Product Change Description

Model Name: T5820
FCC ID: 2AH25T5820
IC ID: 22621-T5820
HW: V01
SW: XQT530_V004_20220923

Model Name: T5820
FCC ID: 2AH25T5820C(approval date: 2023-02-02)
IC ID: 22621-T5820C
Radio Cert. No.: IC: 22621-T5820C(2023-02-14)
HW: V01
SW: XQT530_V004_20220923

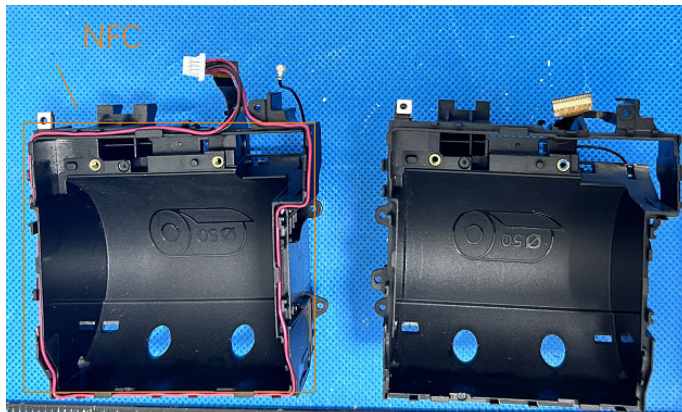
Other changes detailed: Remove nfc and does not affect other RF performance

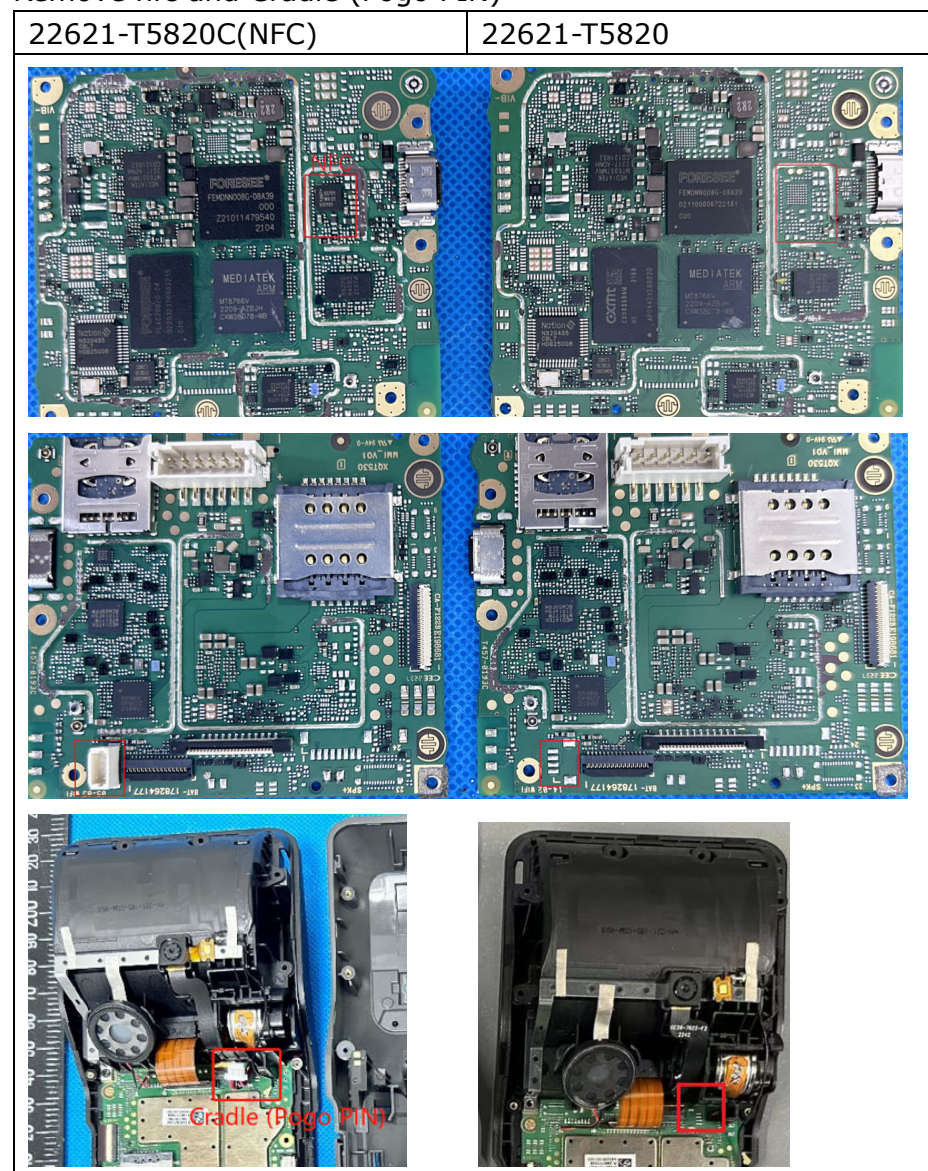
Use new metal front/back cover or keypad: NO
 Mechanical shell changes: Yes
 Remove nfc and Cradle (Pogo PIN)
